25-27 READ STREET

APPLICATION FOR AMENDMENT TO PERMIT

Memorandum from Department of Building Inspection, Portland, Maine

25 Read St. - Building permit for alterations to dwelling for Carl Wright
by Carl Hayden - 5/17/54

Survey of Lot
For
Munson I. Strout
Read Street
Feb. 1947

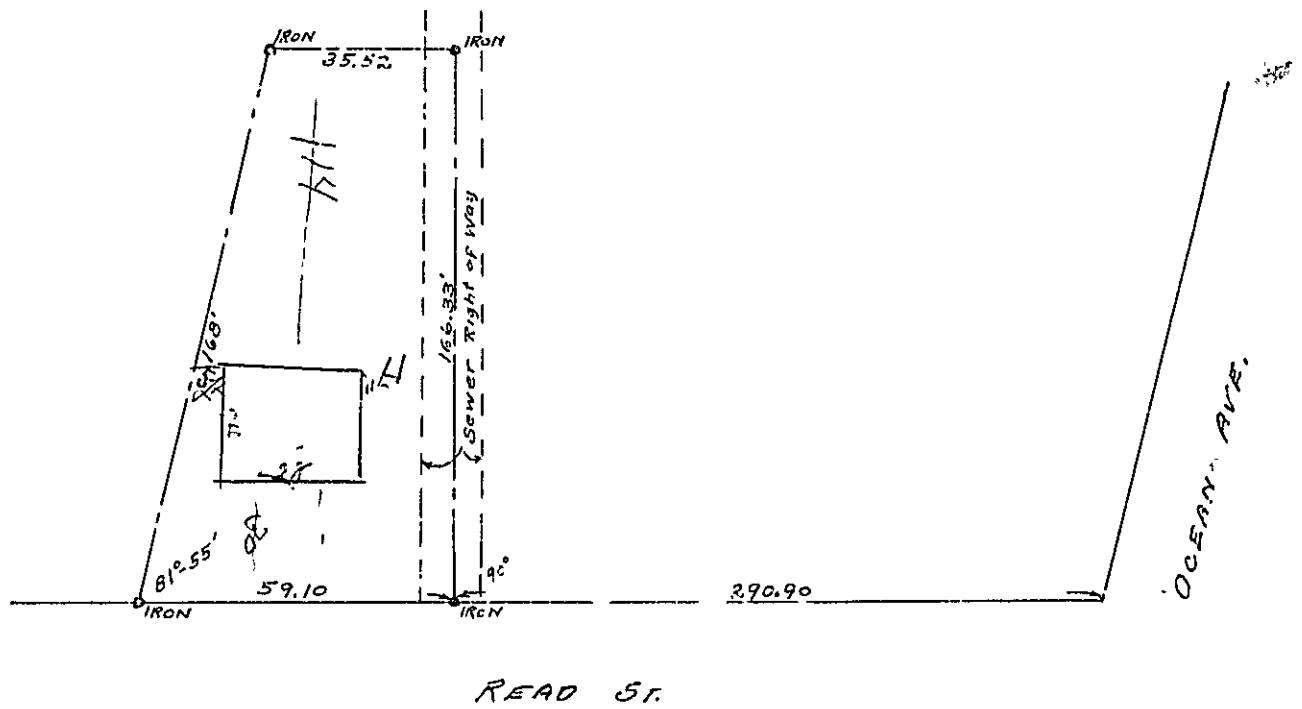
Permit for above work is issued herewith subject to the condition
that all parts of foundation wall will rest upon the original soil and
not upon fill deposited in gulley in front corner of lot to bring grade
up to level of cellar floor.
